Documents for Administrative Record

Comparison of Left Truss (NY Abutment) Measurements

Comparison of Left Truss (NY Abutment) Inspection Report Photos

Comparison of Left Truss Bearings - NY Abutment Photos

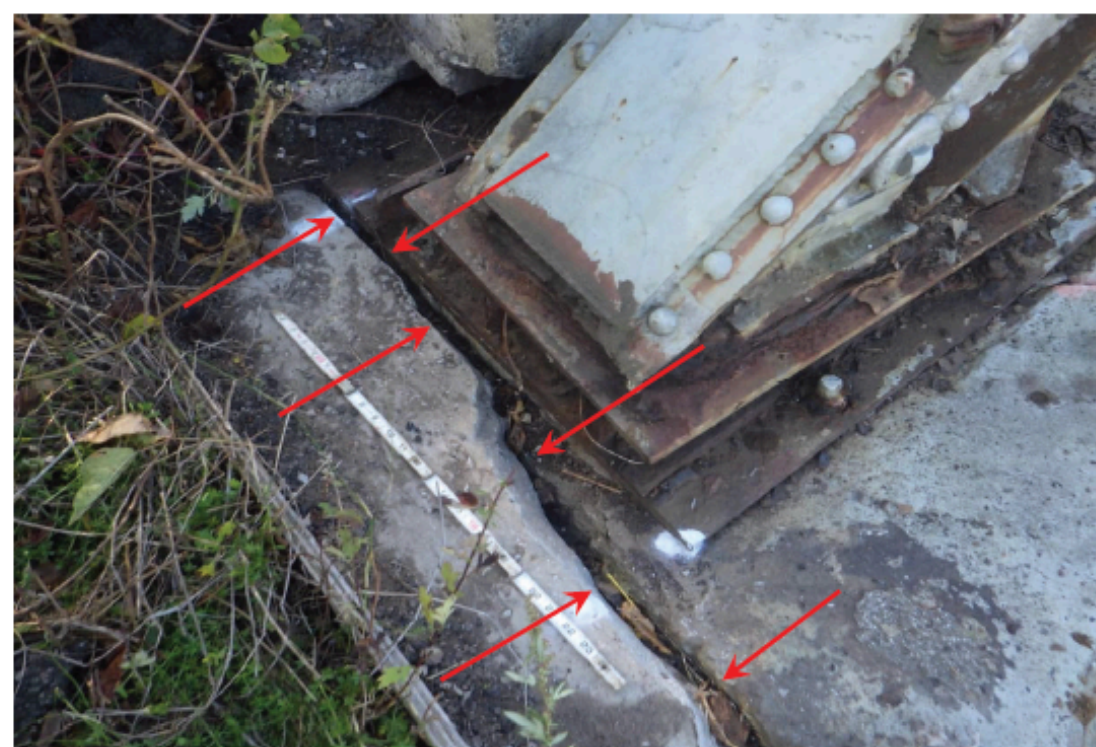
Grout or concrete was applied to hide the settlement by filling the gap visible in the 2017 photos. However, no work addressed the structural forces acting on the abutment.

Not surprisingly, the grout/concrete fractured.

80. Repair done in 2018 adjacent to the Left Truss bearing showing evidence of movement

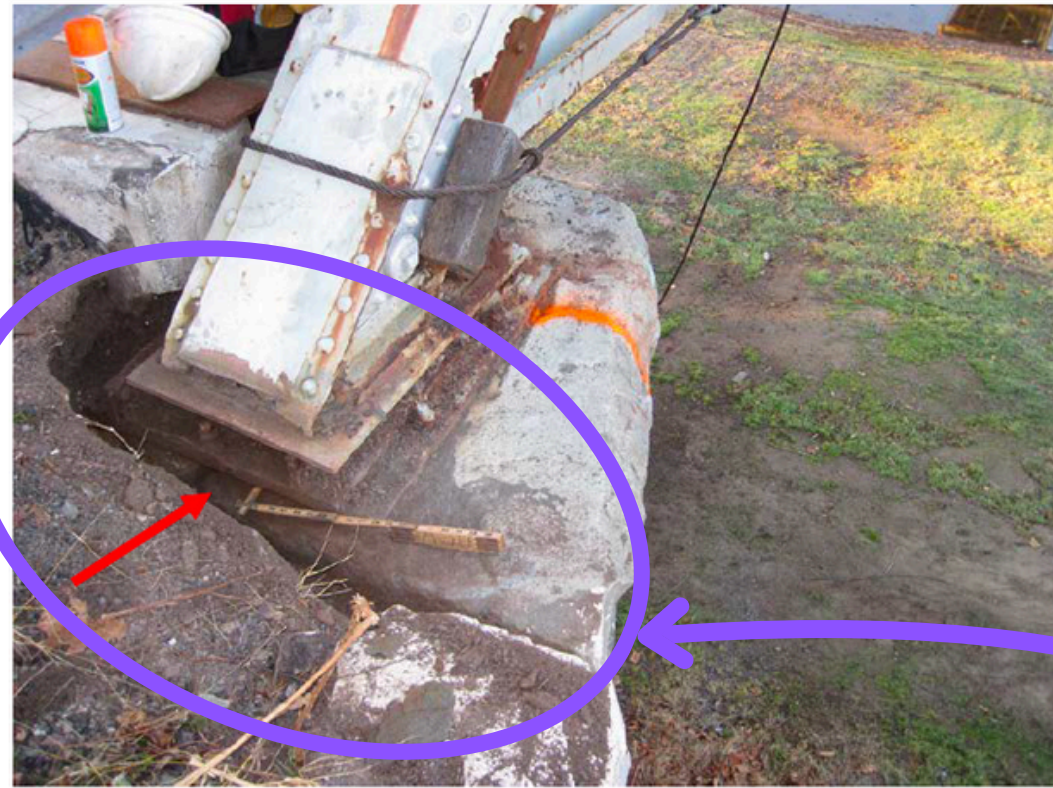
However, the cracked/fractured grout in April 2024 is gone in October, making the "gap" between the failed repair and the truss bearing appear larger than it is

Here, PennDOT claims "evidence of movement", pointing to the gap between the failed concrete repair and the truss bearing, *but does not have previous measurements*

This alleged “gap” is merely what was previously visible in 2017 becoming visible again as the “grout repair” erodes and fractures. The “gap” between the grout repair and the truss bearing is not “evidence of movement,” but merely the failure of the concrete to correct the lateral forces acting on the bridge abutment. Further, there is no measurement of this “gap” prior to Oct. 2024 for comparison.
